MSEX3052A-01

S E R V I C E N O T E

MSEX3052A – Oscilloscope, Mixed Signal, 2+8 Channel,
500MHz

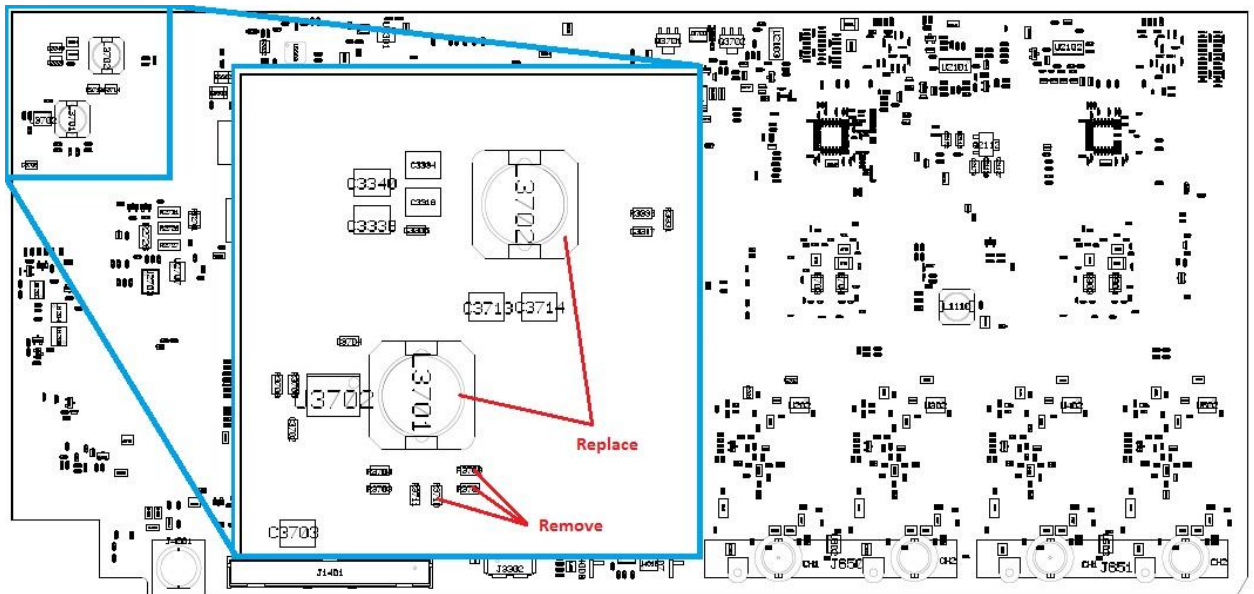
With the oscilloscope power turned on and while under normal operation, the unit emits a hissing noise.

2. As the picture indicates, remove the three resistors (0699-7209, 1 Ohm) located at R3701, R3709, and R3710. They are not to be replaced.
3. Remove as well the two inductors (9140-6474, 100uH) located at L3701 and L3702 and replace them with inductors with part number 9140-6151 (68 uH).
4. Re-assemble to the point where the unit could be powered up to verify that the hissing is indeed gone. If the hissing is not gone, please, check modifications.
5. When the hissing is gone, put oscilloscope back together.
